**CITY OF SNELLVILLE  
DEPARTMENT OF PLANNING & DEVELOPMENT  
MAYOR AND COUNCIL**

**CASE SUMMARY**

**July 10, 2023**

<b>CASE NUMBER:</b>	<b>#RZ 23-03 SUP 23-02</b>
<b>REQUEST:</b>	<b>Rezoning and Request for Special Use Permit</b>
<b>LOCATION:</b>	<b>1000 Athens Highway, Snellville, Georgia</b>
<b>SIZE:</b>	<b>22.81± Acres</b>
<b>TAX PARCEL:</b>	<b>5100 065</b>
<b>CURRENT ZONING:</b>	<b>BG (General Business) District</b>
<b>REQUESTED ZONING:</b>	<b>MU (Mixed-Use) District</b>
<b>CURRENT FUTURE LAND USE MAP DESIGNATION:</b>	<b>Highway 78 East Activity Center/Node</b>
<b>SPECIAL USE PERMIT REQUEST:</b>	<b>Multi-family Dwellings</b>
<b>DEVELOPMENT/PROJECT:</b>	<b>300 Multi-family Units; 28 Single-family Townhome Units; 51,000 SF Retail, Commercial, Office and Amenity Space Mixed-Use Development</b>
<b>PROPERTY OWNER:</b>	<b>The Kroger Co. Cincinnati, Ohio 45202</b>
<b>APPLICANT/CONTACT:</b>	<b>Highpoint Development Atlanta, Georgia 30309 ATTN: Jeff Timler. Split Silk Properties LLC 678-772-0202 <a href="mailto:splitsilkproperties@gmail.com">splitsilkproperties@gmail.com</a></b>

Conceptual Zoning Plan – Highpoint Development

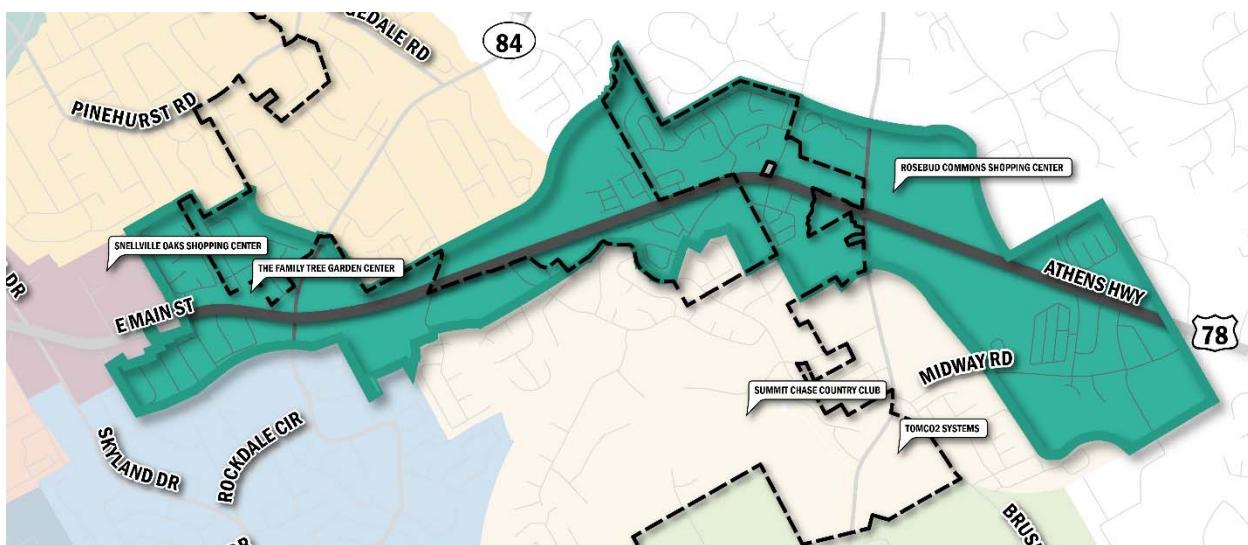
The 300 multi-family units and 28 townhome units (328 total units) equals 14.37 units per acre, exceeding the maximum site density of 12 units per acre (273 total units) by 55 units.

As indicated in the table above, the 15-foot building height for Outparcel 3 and Outparcel 4 are nonconforming to the 2-story or 24-feet (whichever is greater), minimum building height of UDO Sec. 203-4.10.

Variance Analysis: The applicant is requesting waiver from the stub-out street and interparcel-access requirement to the adjacent property to the west (parcel 5101 571)

due to extreme topographic conditions and 100-feet buffer and 150 feet impervious buffer; and to the adjacent property to the south (parcel 5100 023) as connectivity is not feasible due to traffic and potential incompatible uses through the residential component of the development.

The Planning Department agrees that inter-parcel connectivity to the adjacent parcel to the west is not feasible due to existing site and environmental conditions. However, inter-parcel connectivity to the adjacent 18± acre property to the south is warranted as this property was also designated as Highway 78 East Activity Center/Node on the August 2022 amendment to the Future Land Use Map and allowing for the potential rezoning to the MU District or other zoning district as appropriate in the Highway 78 East Activity Center/Node.

The Planning Department recommends *approval* where adjacent to parcel 5101 571. The Planning Department recommends *denial* where adjacent to parcel 5100 023.

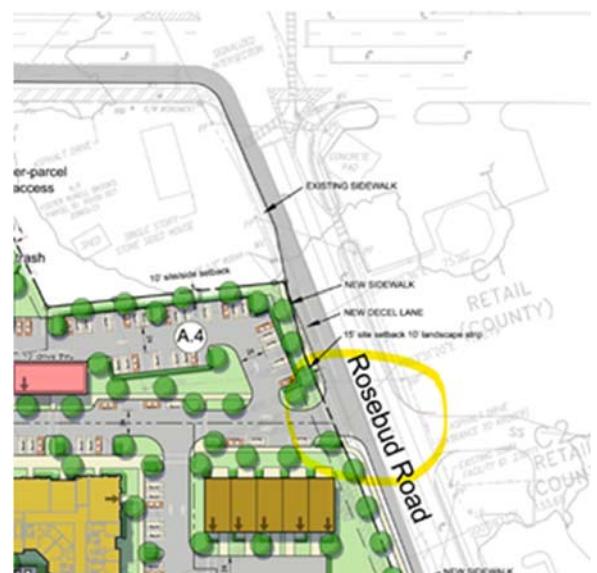
5. The applicant uses ITE Code 221 for the multifamily which describes this as “Mid-rise multifamily housing includes apartments and condominiums located in a building that has between 4 and 10 floors of living space.” The site plan shows the multifamily units are between 3 and 4 floors. Why was ITE Code 220 not used? The renderings do not show buildings greater than 4 floors. See the table below for the trip generation difference between ITE Code 220 and 221.

6. Per Section 900-10 of the Unified Development Ordinance (UDO), the following minimum right-of-way is required:
- 75 feet from the centerline of Athen Highway (principal arterial) – this minimum appears to already be in place, with it appearing to be 80 to 90 feet.

- 50 feet of from the centerline of Rosebud Road (minor arterial) – There appears to currently be 35 to 40 feet in place, so additional right-of-way would be needed along this frontage.

- The primary access along Rosebud Road appears to be slightly offset from the Rosebud Road Kroger access point, approximately 375 feet south of the intersection with Athens Highway, and is located at a point of conflict with the Rosebud Road NB left-turn lane storage.
  - GCDOT recommends the applicant provides a continuous right-turn lane along Rosebud Road because of the continued growth in this area of the county.
9. Per the Gwinnett County Trails Master Plan and Section 900-100, the applicant must provide a 10-foot concrete trail along each frontage. This trail must be within right of way. Does it have to be concrete?
